Enclosure 1

Marked up versions of the Environmental Report
showing changes made under revisions 10a, 10b, 10c and 10d

ENVIRONMENTAL REPORT

REVISION 10d

Figure 3.3-5 Preliminary Site Boring Plan and Profile

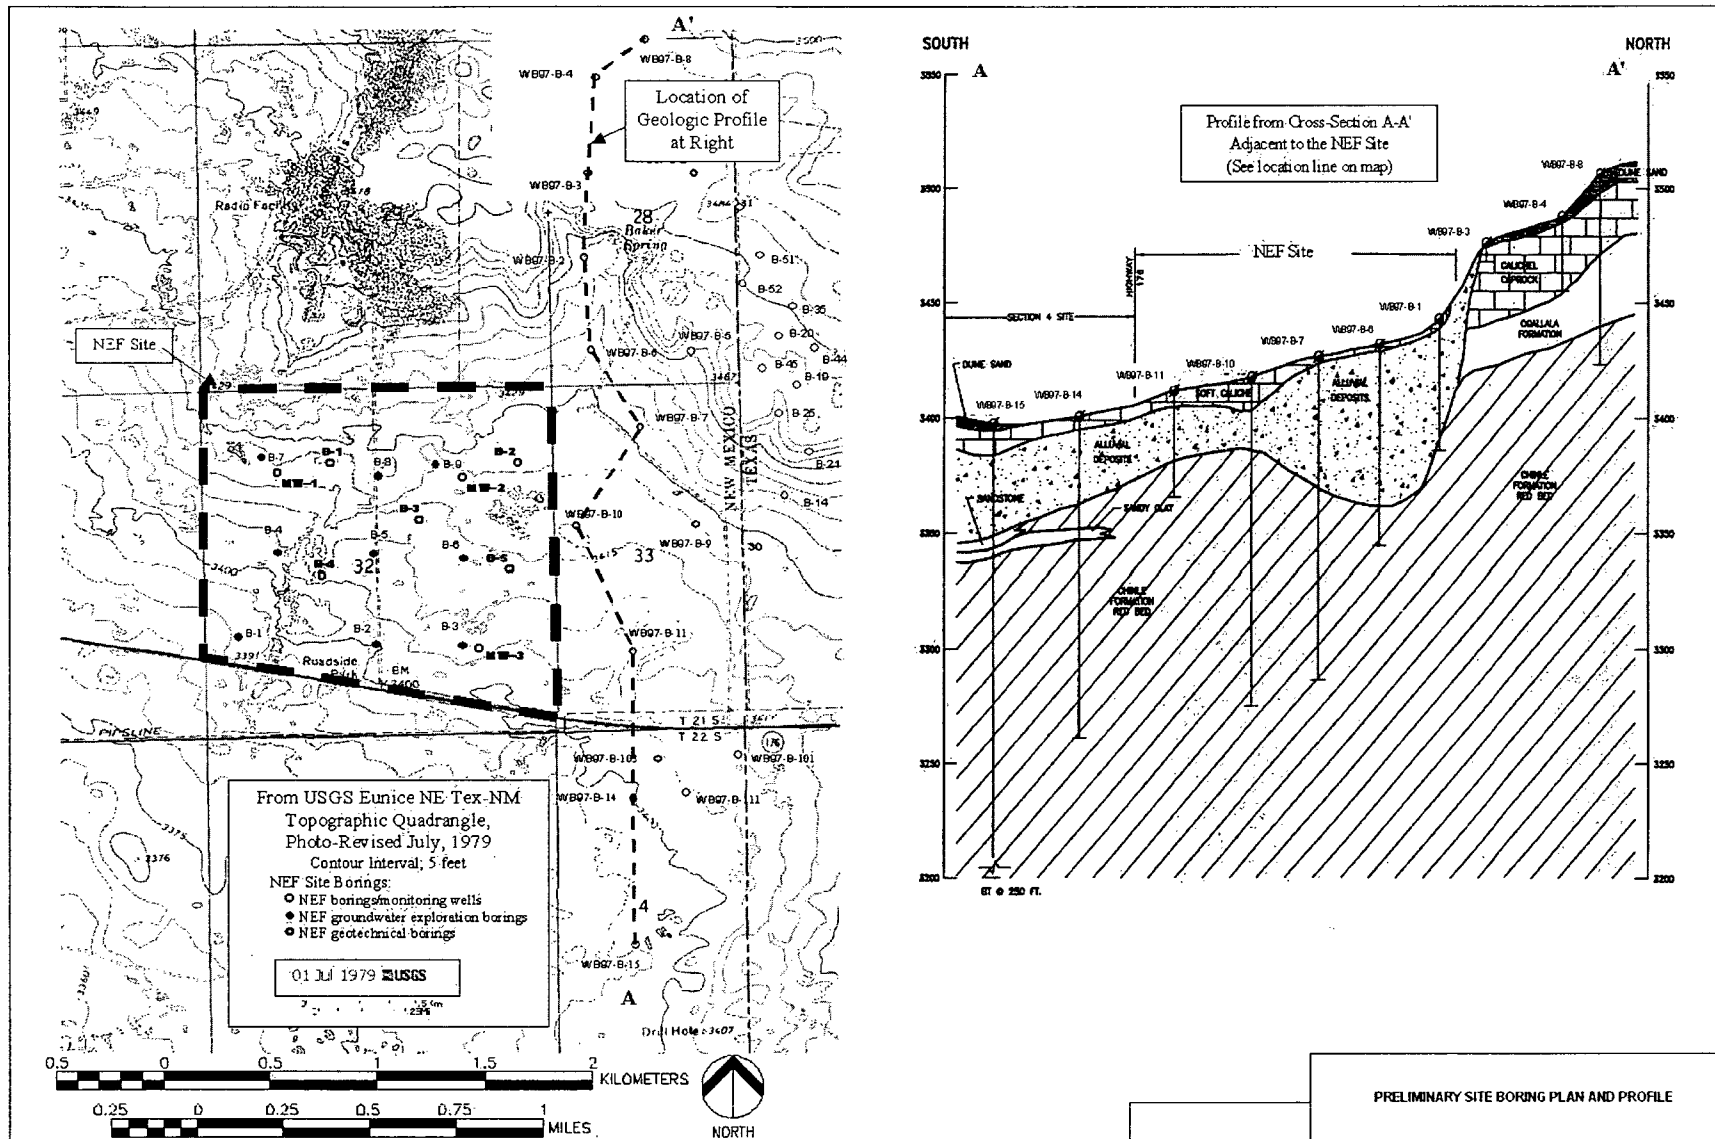
~~The t~~Three monitoring wells were installed at the end of September 2003 (Figures 3.3-5 and 3.4-6). Through the first month of monitoring only one well, MW-2, located at the northeast corner of the site, produced water. Several water samples have been taken from that well. It is was anticipated that the other two wells ~~may~~ would provide water over lengthy time periods, based on information from the WCS site. Groundwater quality is discussed in ER Section 3.4.2, Water Quality Characteristics. In 2007, fifteen additional ground water monitoring wells were drilled at locations depicted on Figure 6.1-2A, and monitoring well MW-3 was plugged and abandoned because of its location in the footprint of the Storm Water Basin

Three monitoring wells ~~have been~~ were initially drilled and installed on the NEF site, i.e., MW-1, MW-2, and MW-3 shown on Figure 3.3-5, Preliminary Site Boring Plan and Profile and Figure 3.4-6, Dockum Group (Chinle Formation) Surface Contour, and yielded several water quality samples. The results of the water quality analyses are summarized in Table 3.4-3, Chemical Analyses of NEF Site Groundwater. Water quality characteristics are similar to those for WCS site samples. No local groundwater well sites and, as a result, groundwater data are available with the exception of groundwater well sites on the WCS site and those that have been installed on the NEF site. Additional groundwater sampling and analysis of the onsite monitoring wells will be conducted on a frequency needed to establish a baseline.

Figure 3.4-6 Dockum Group (Chinle Formation) Surface Contour

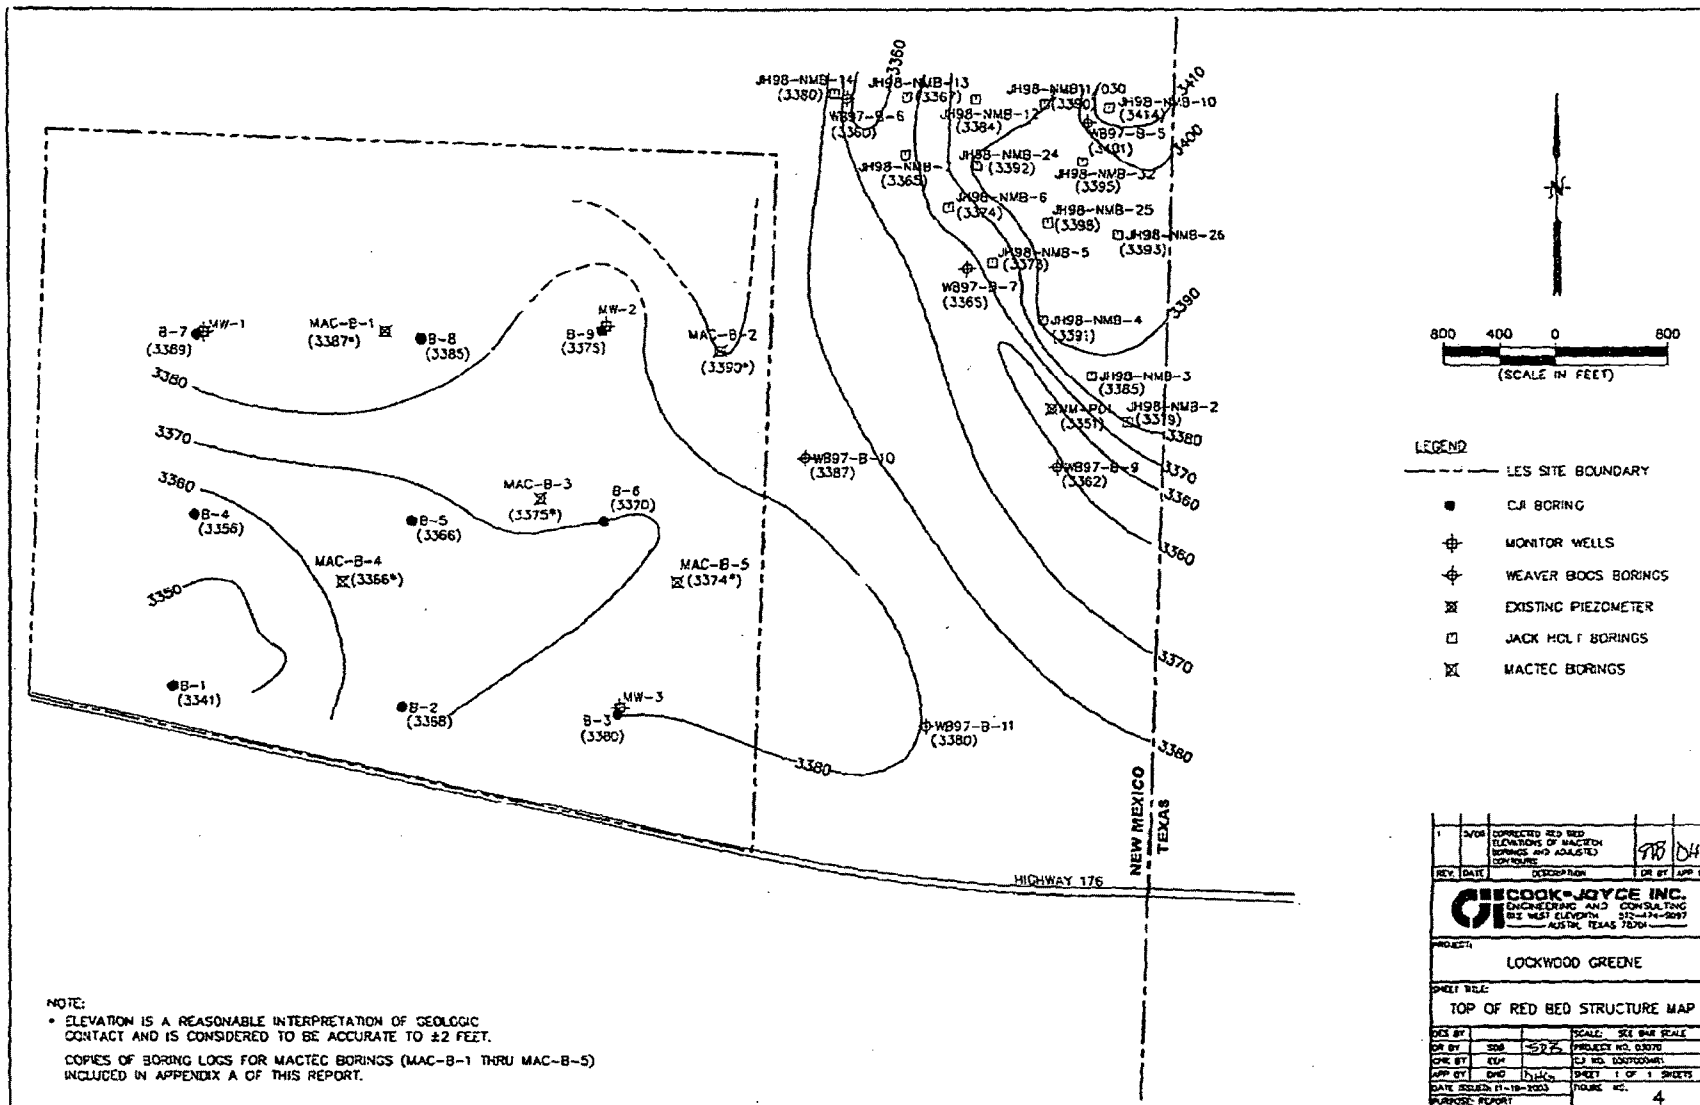
Three monitoring wells were initially installed at the site (Figure 3.4-6). These three monitoring wells ~~are~~ were designated MW-1 through MW-3. Screens for those wells were placed in a siltstone layer within the Chinle clay based on resistivity logs at depths of about 70 m (230 ft) below the ground surface. The water bearing zone, referred to as the 230-zone, is approximately 4.6 m (15 ft) thick and is encountered at depths ranging from 65 to 68 m (214 to 222 ft) below ground level. Only one well, MW-2, adjacent to B-9 and near the northeast corner of the site, has produced water. Measured head for groundwater in the well is at an approximate elevation of 1,009 m (3,311 ft) msl. Results of chemical and radiological analyses of water samples from that well are provided in Table 3.4-3, Chemical Analyses of NEF Site Groundwater.

Three monitoring wells were ~~recently~~initially installed at the NEF site, i.e., MW-1, MW-2 and MW-3 shown on Figure 3.4-6, Dockum Group (Chinle Formation) Surface Contour. They ~~are~~being~~were~~ monitored for inflow of groundwater. The well screens ~~are~~were located at the first occurrence of groundwater beneath the site, some 65 to 68 m (214 to 222 ft) below land surface. They ~~are~~were set in a siltstone or silty sandstone that has very low permeability. Monitor wells tapping the same unit to the east of the site on the WCS property are also slow to recover after drilling and sampling operations. Some of the wells never appear to equilibrate between sampling events.
